**PARK CITY BOARD OF ADJUSTMENT MEETING
SUMMIT COUNTY, UTAH
May 21, 2024**

6.A. **341 Ontario Avenue – Appeal** – The Applicant Appeals the Planning Director's Denial of a Historic District Design Review Modification for the Relocation of a Hot Tub and New Stairs in the Side Setback on a Significant Historic Site and Steep Slope in the Historic Residential-1 Zoning District. PL-24-06091
(A) Public Hearing; (B) Action

Subject: 341 Ontario Avenue
Application: PL-24-06091
Author: Lillian Zollinger, Planner II
Date: May 21, 2024
Type of Item: Appeal of Historic District Design Review Modification Denial

2 STAIR & FINAL GRADE
1/4" = 1'-0"

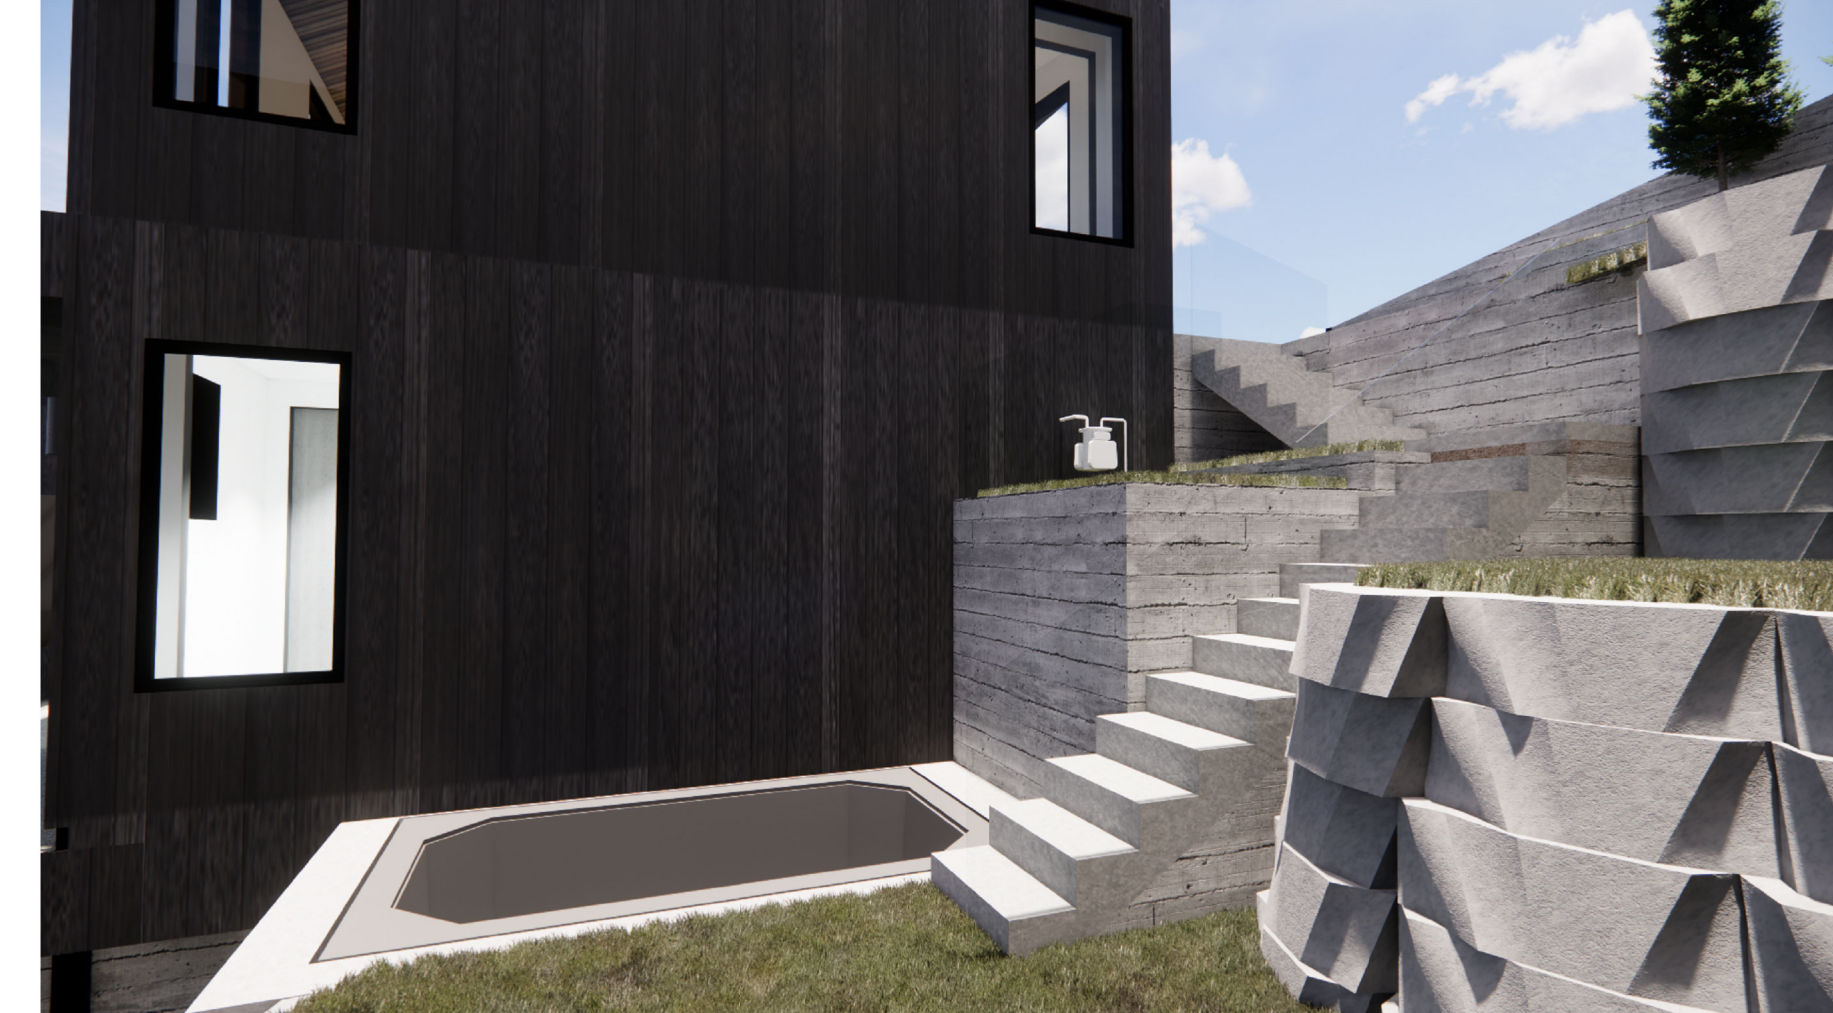
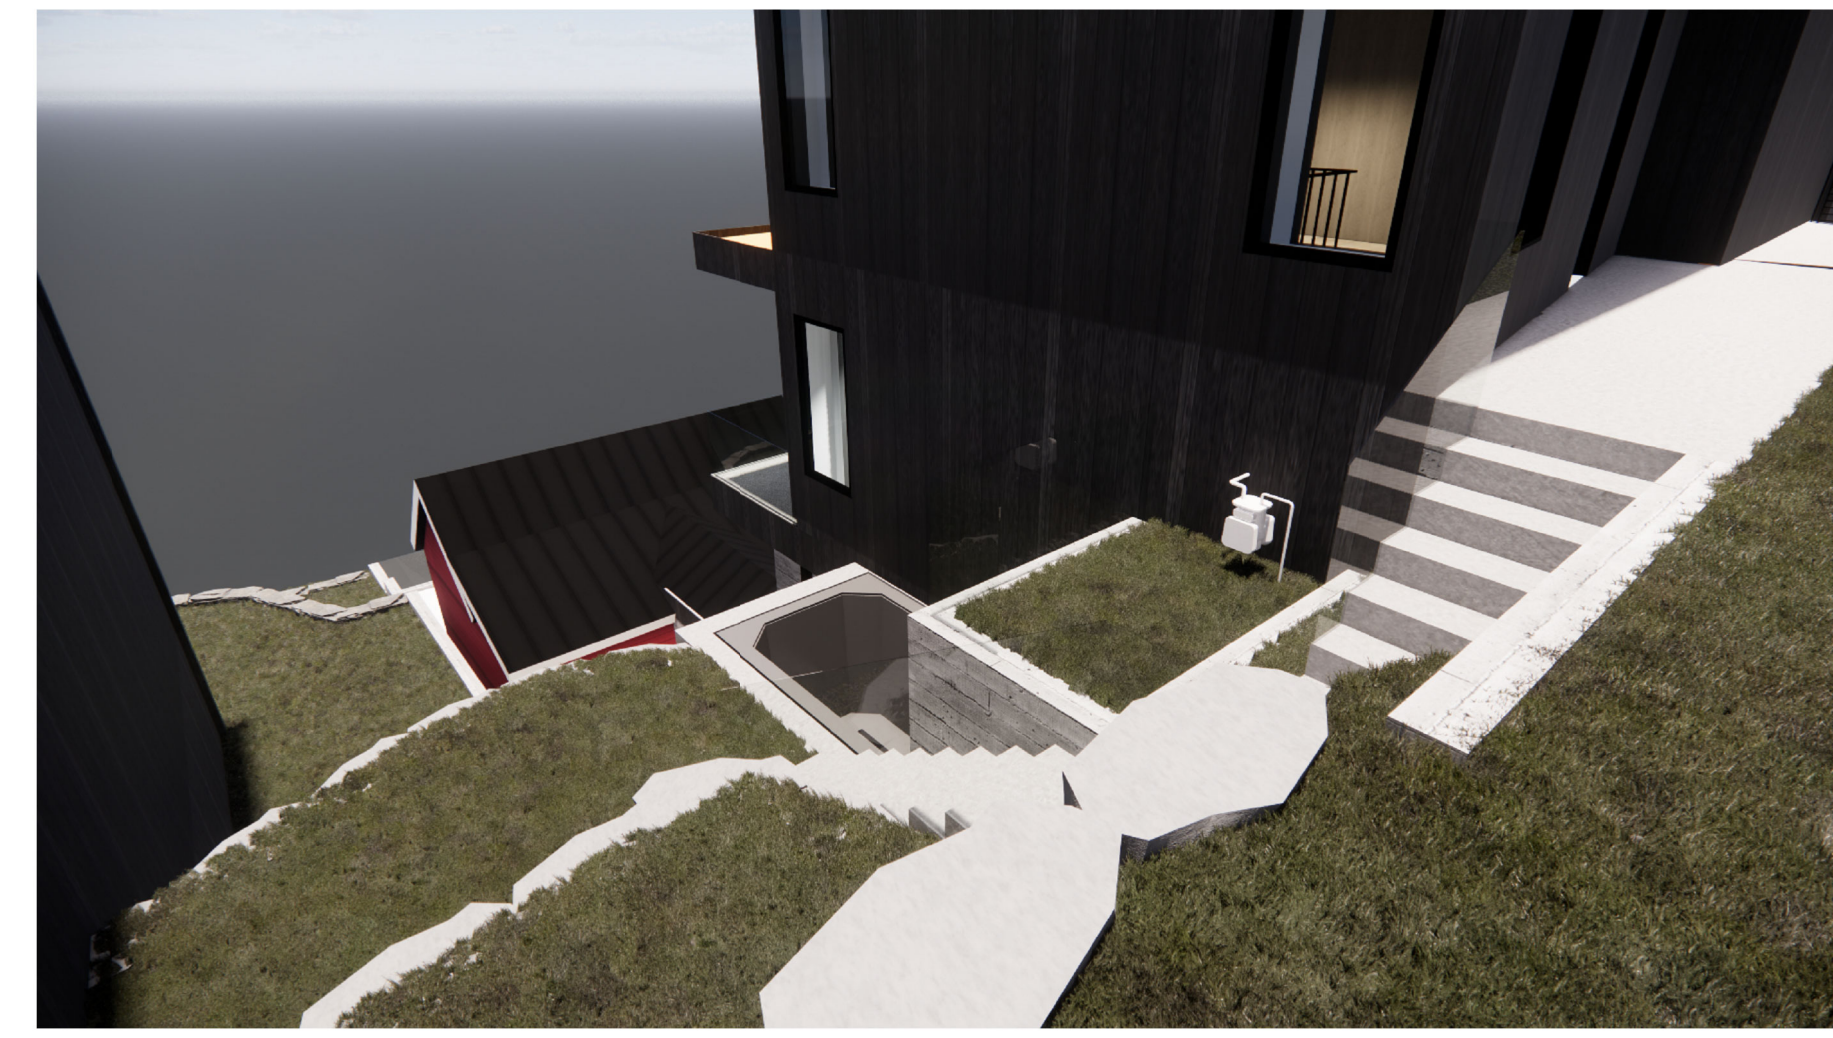
15. On March 29, 2024, the Planning Director denied the HDDR Modification, finding the following:
 1. "Land Management Code (LMC) § 15-2.2-5 outlines height requirements for the Historic Residential – 1 Zoning District and states final grade must be within four vertical feet of existing grade, except for window wells, emergency egress, and a garage entrance. The hot tub is not a window well, emergency egress, or garage entrance and is proposed to be sunken into grade by five feet, eight inches disturbing existing grade by five feet, eight inches and therefore does not comply.

2. LMC § 15-2.2-6 outlines requirements for development on Steep Slopes within the Historic Residential – 1 Zoning District and states, "[d]evelopment on Steep Slopes must be environmentally sensitive to hillside Areas, carefully planned to mitigate adverse effects on neighboring land and Improvements, and consistent with the Design Guidelines for

As determined by the Planning Director, LMC [§ 15-13-2\(B\)\(1\)\(b\)\(1\)](#), LMC [§ 15-13-2\(B\)\(1\)\(b\)\(2\)](#), and past approvals, the Applicant is required to return the site to as close to existing grade as possible. The proposed in-ground hot tub and stairs on a Very Steep Slope further impact the final grade of the historic site and do not bring the grade into closer compliance with existing grade.
